3043214	SUMMIT HOMES - COBEY CREEK #23 - 1ST LVL	512 SE CARTER RD	LEE'S SUMMIT, MO	TODD W MOORE	1/13/2022
JOB No.	DESCRIPTION	JOB ADDRESS	CITY	DISIGNER	DATE

ROOF TRUSS LAYOUT

EVERSTEAD SHOP DRAWINGS/SUBMITTAL REVIEW

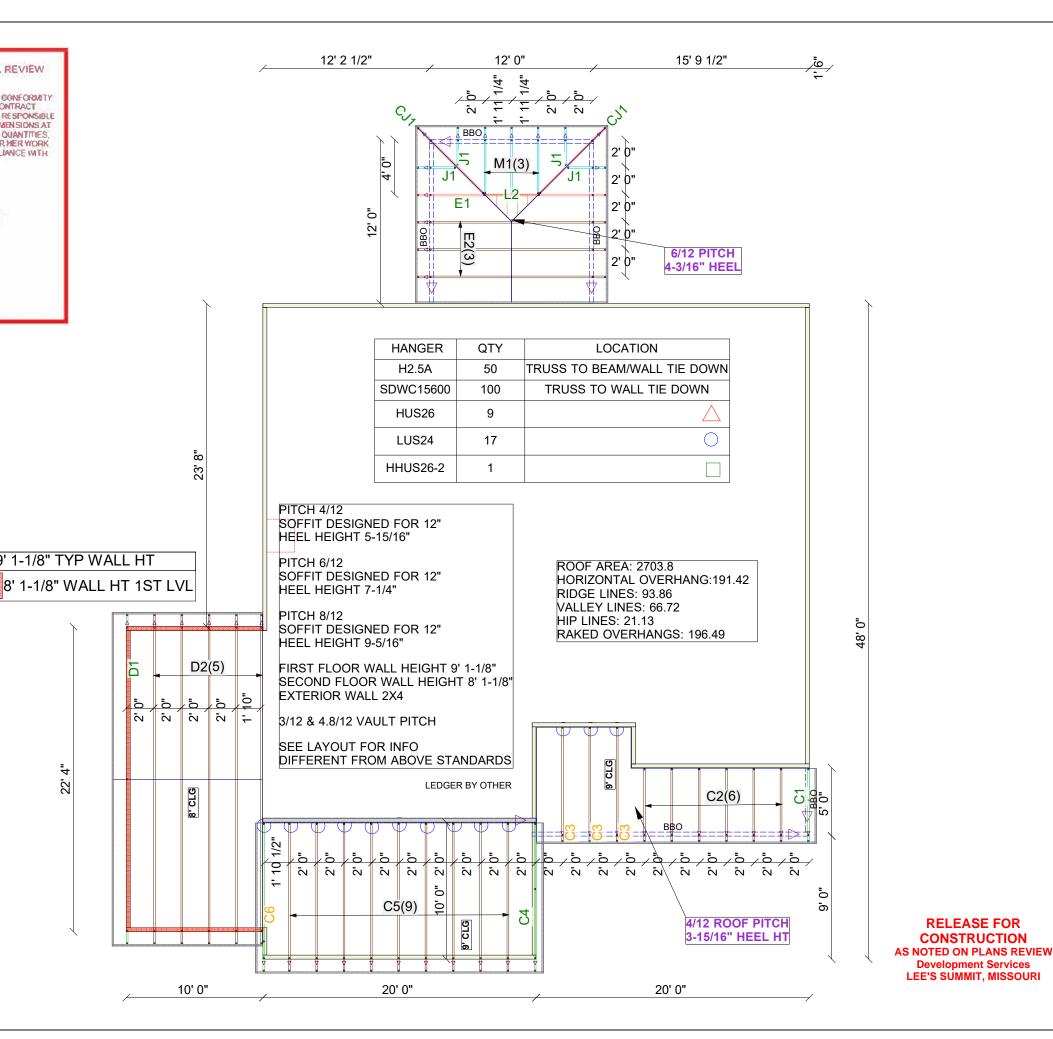
SUBMITTAL WAS REVIEWED FOR DESIGN CONFORMTY AND GENERAL CONFORMANCE TO CONTRACT DOCUMENTS ONLY THE CONTRACTOR IS RESPONSIBLE FOR CONFIRMING AND CORRELATING DIMENSIONS AT JOBSITE FOR TOLERANCE, CLEARANCE, QUANTITIES, FABRICATION, COORDINATION OF HIS OR HER WORK WITH OTHER TRADES, AND FULL COMPLIANCE WITH CONTRACT COCUMENTS

APPROVED 01/31/2022
